Access Compliance Report

Public Rights-of-Way

(Curb Ramps)

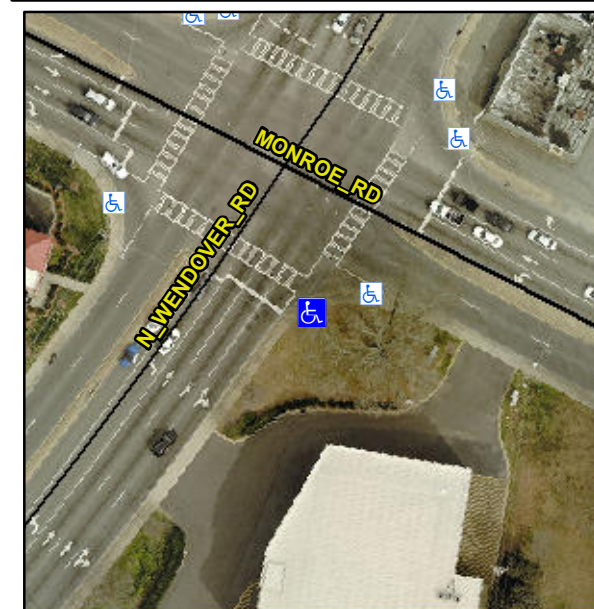
Not Found, R304.5.1, R304.2.2

Compliance	Description	Data	Compliance	Description	Data
N/A	Ramp Length (in)	61.0	No	Ramp Slope (%)	9.4
No	Ramp Width (in)	42.0	Yes	Ramp XSlope (%)	1.3
N/A	Flare Type LT	N/A	N/A	Flare Type RT	N/A
N/A	Flare Slope LT (%)	N/A	N/A	Flare Slope RT (%)	N/A
N/A	Flare Traversable LT?	N/A	N/A	Flare Traversable RT?	N/A
N/A	Landing Length (in)	N/A	N/A	DWS Provided?	N/A
N/A	Landing Width (in)	N/A	N/A	DWS Contrast?	N/A
N/A	Landing Slope (%)	N/A	N/A	DWS Length (in)	N/A
N/A	Landing X Slope (%)	N/A	N/A	DWS Full Width?	N/A
N/A	Landing Curb? (Y/N)	N/A	N/A	DWS Offset (in)	N/A
N/A	Shared Landing?	N/A			
N/A	Gutter Ponding?	N/A	N/A	Gutter Slope (%)	N/A
N/A	Gutter Lip Ht (in)	N/A	N/A	Gutter X Slope (%)	N/A
N/A	Painted X Walk1?	Yes	N/A	Painted X Walk2?	Yes
	X Walk 1 Direction	To NE		X Walk 2 Direction	To NW
N/A	X Walk 1 Width (in)	115.0	N/A	X Walk 2 Width (in)	104.0
	X Walk 1 Slope (%)	1.4		X Walk 2 Slope (%)	1.3
	X Walk 1 X Slope (%)	2.7		X Walk 2 X Slope (%)	2.7

Remove & Replace Curb Ramp With Two New Directional Ramps or Equivalent. Restripe Crosswalk.
